Karim Textiles Limited(Extension)

Noorbag, Kaliakor, Gazipur, Bangladesh
Geographic Coordinates: 24.019730N, 90.300313E
07 September 2023

1. **Building-3:** This structure is a nine storied (B+G+8) reinforced concrete (RC) building with one basement.

ENGINEERING ASSESSMENT REPORT OF 9-STORIED INDUSTRIAL BUILDING WITH SEMI BASEMENT REINFORCED CONCRETE BUILDING- OF KARIM TEXTILES LTD. AT NOORBAG, KALIAKOIR, GAZIPUR.

NTPA Load and Combination used for structural integrity

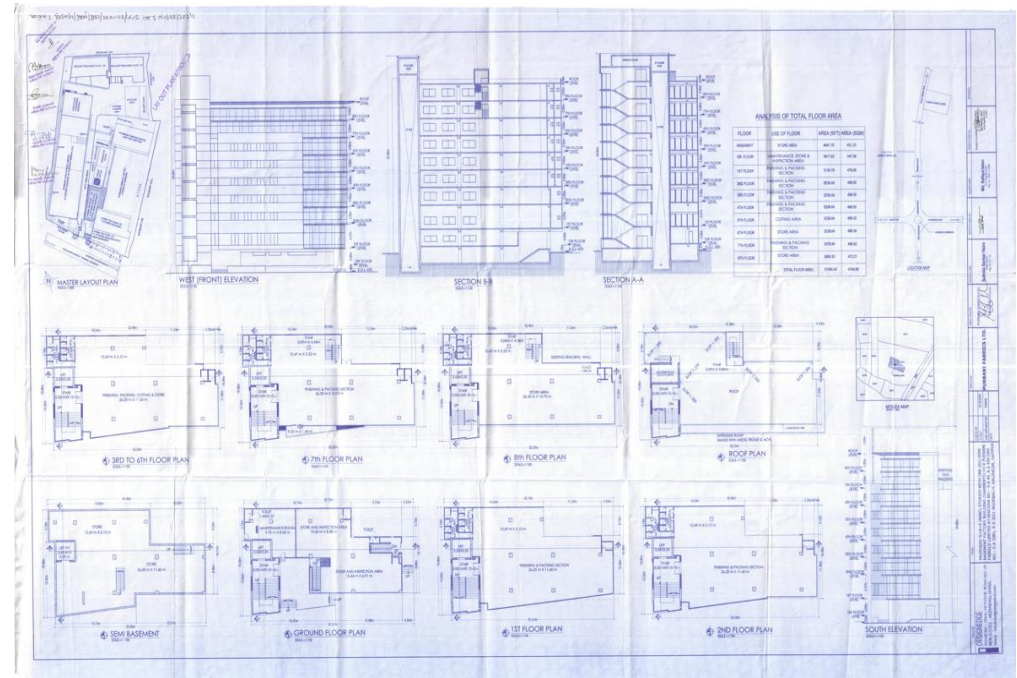
The building construction was started in April 2013 and ended in November 2014. Approval from local authority from April 2013. The factory occupied the structure since December 2014. But in the design report software-based analysis load combination had been considered as NTPA which doesn't comply with BNBC part-6.

Building engineer is required to revised the prepared design report as per BNBC part-6.

Live load table (BNBC part-6)

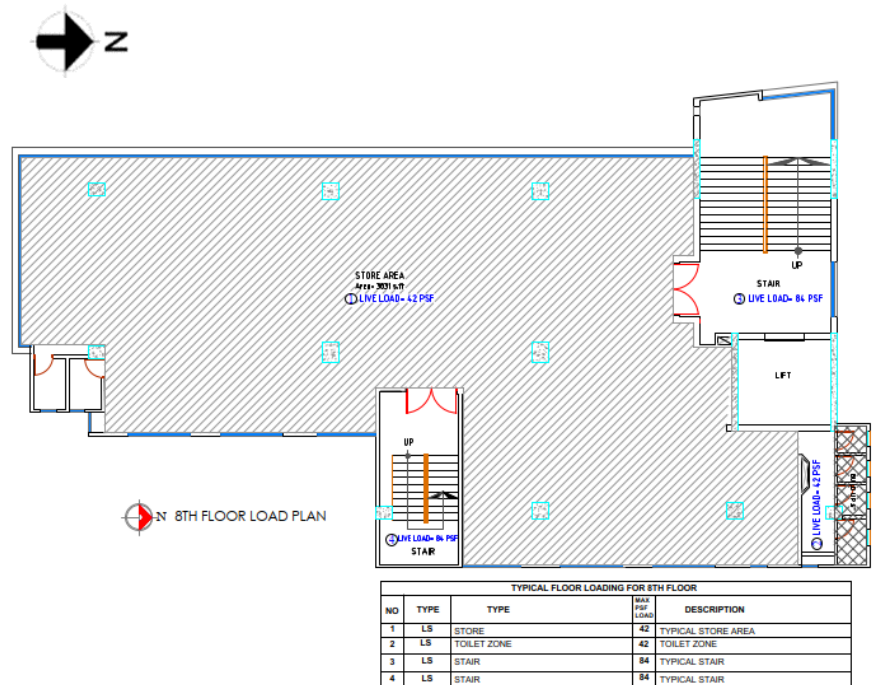
Typical Live load considered as 2 KPa

Typical live load considered as 2 kPa in all floors. As per BNBC- Part 6, live load for light workroom area is required to be considered minimum 3 kPa and light storage to be considered minimum 6 kPa . Building engineer is required to revise the load plan as per BNBC requirement.

R=8 (IMRF) Considered in the design and analysis

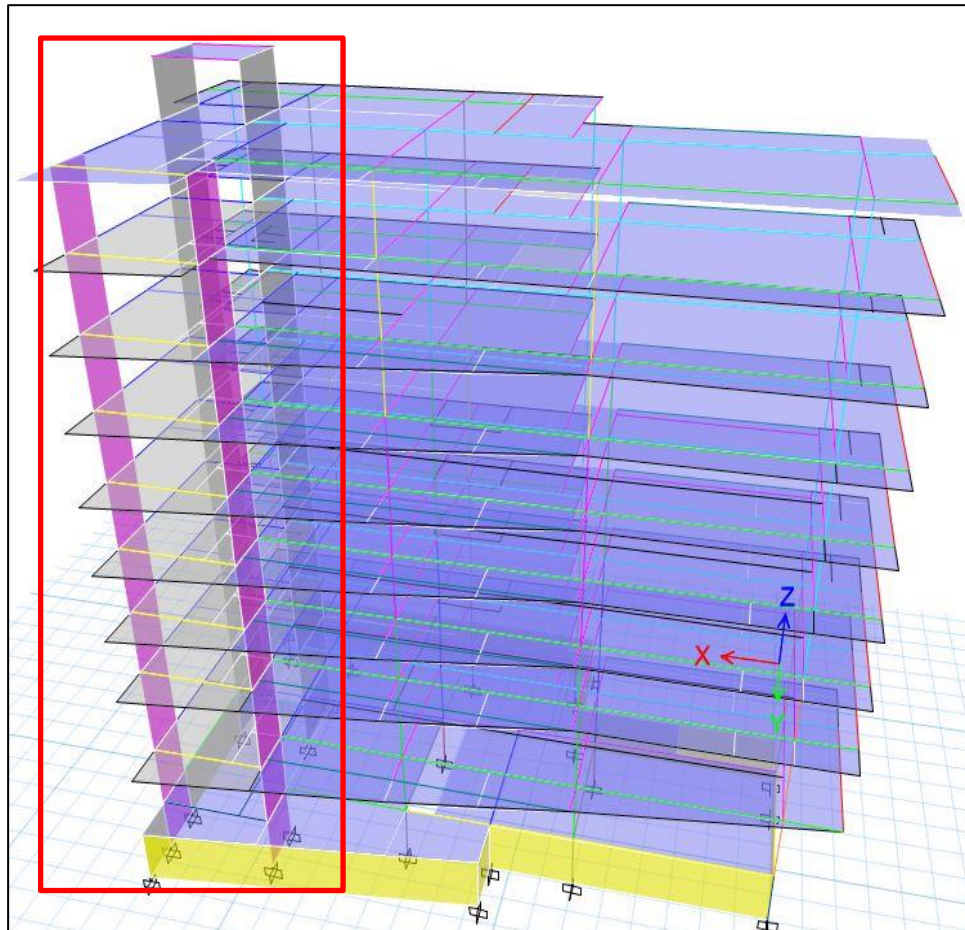
IMRF had been considered in the design and analysis, but no clarification was shown according BNBC-2006 part-6 section 8.3.10. Building engineer is required to incorporate all the terms & conditions of BNBC-2006 part-6 section 8.3.10 with comparing all types of beam-column frame in the design report.

RC wall adequacy checks missing in the design report

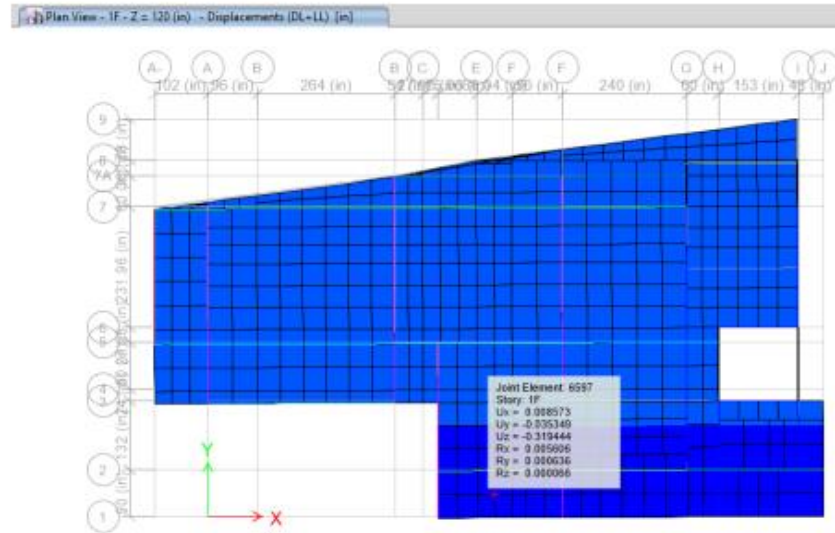
In the design report RC wall (stair & lift) adequacy checks were not incorporated at all. Building engineer is required to incorporate all type of design check for the RC wall adequacy as per the BNBC.

Deflection checks against gravity loading

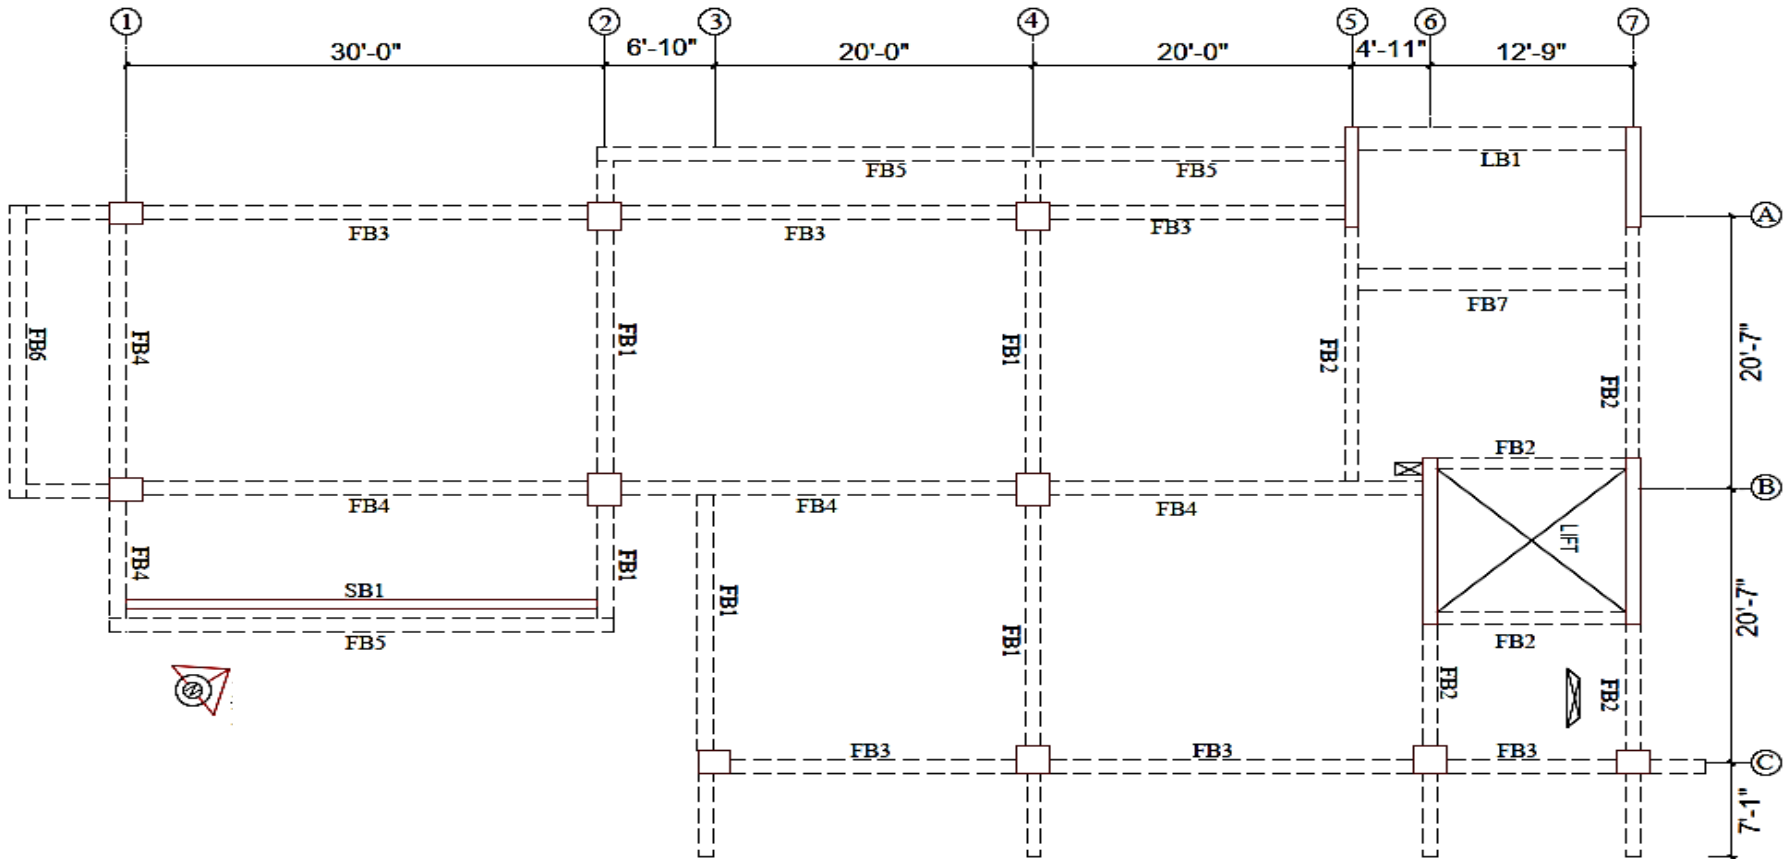
Deflection and drift study shall be added against lateral loading also. Building engineer is required to incorporate the deflection, drift and building separation study as per NBC-2006 part-6 section-1.5.6.

Floor Beam Layout Plan

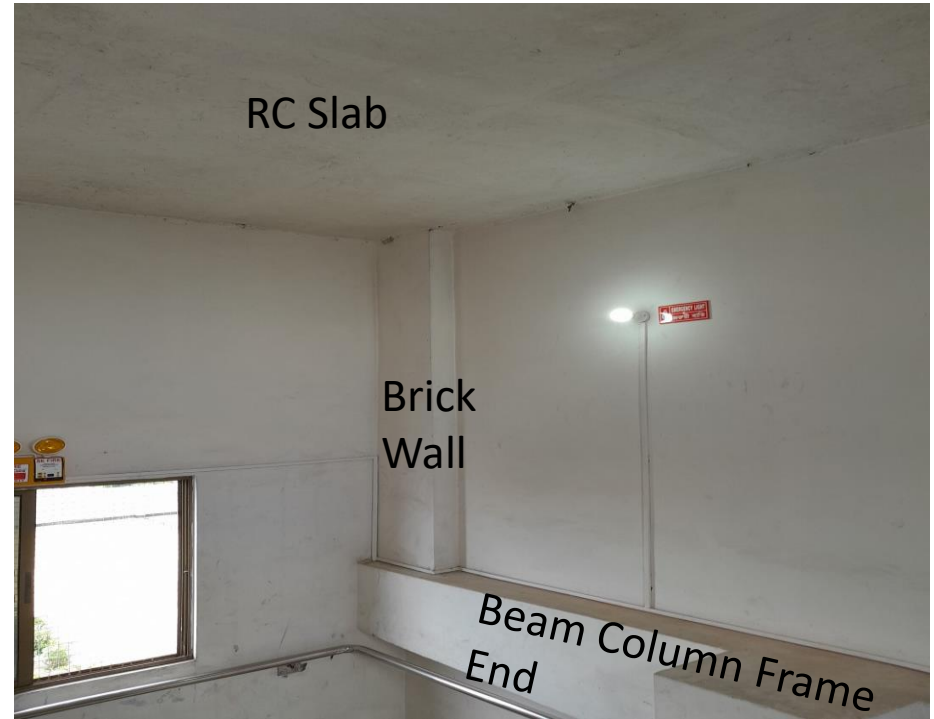
Lack of information of cantilever beam found in the as-built drawing. Building engineer is required to provide details of cantilever beams (Dimension, Size).
